SUBJECT: Bridge No. 6, W P. 279-64-5, Site No. 37-796,  
Dundas St. Overpass at E. Mall, District No. 6.

Bridge No. 6  
Dundas St. Over the East Mall  
W.P. 279-64-S, Site No. 37-796  
Dundas & Hwy. 27 Interchange  
District No. 6

FOUNDATION INVESTIGATION REPORT  
For  
The Proposed Dundas St. and Hwy. #27  
Interchange and Bloor St. Underpass,  
Hwy. #27 -- District #6 (Toronto)  
W.J. 66-F-103 -- W.P. 275-64-2

GENERAL ARRANGEMENT			
APPROVED	DESIGNED	CHECKED	DATE
DEC 67	LOADING	1967-44	1967-44
DRAWING No.	CONTRACT No.	DATE	DATE
6201-1

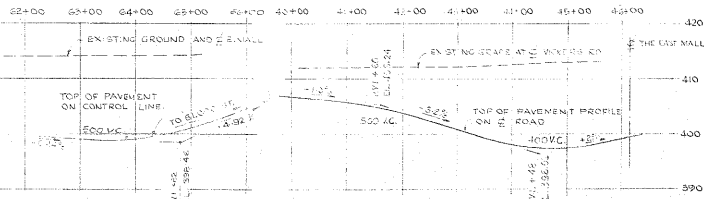
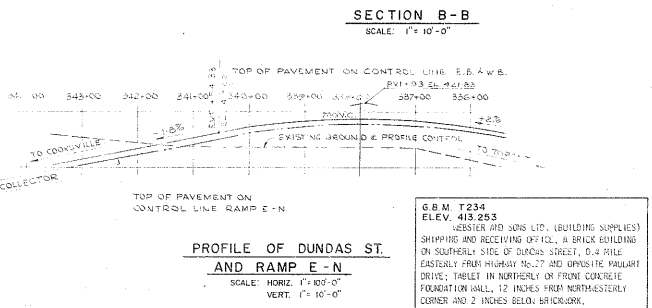
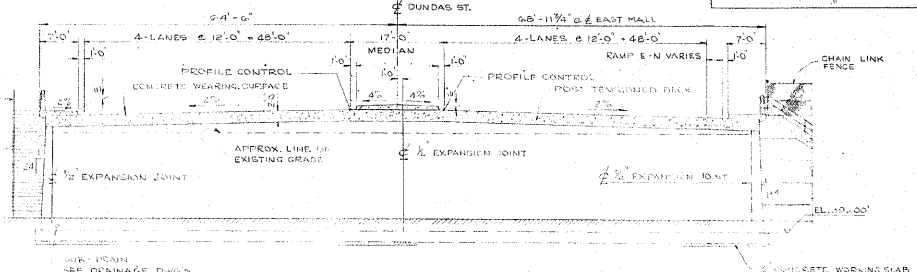
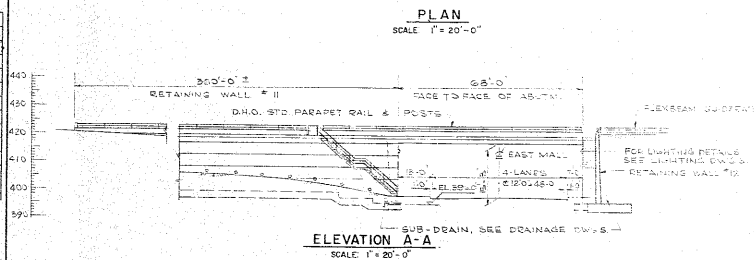
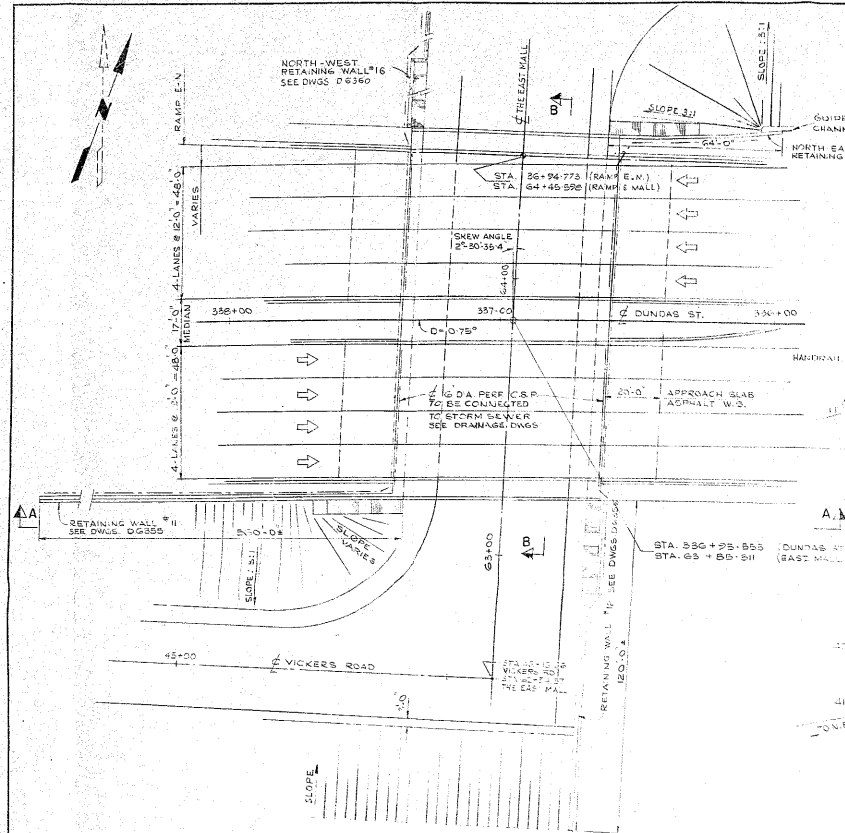
No Comment: Oct 12<sup>th</sup> 67

No comments.
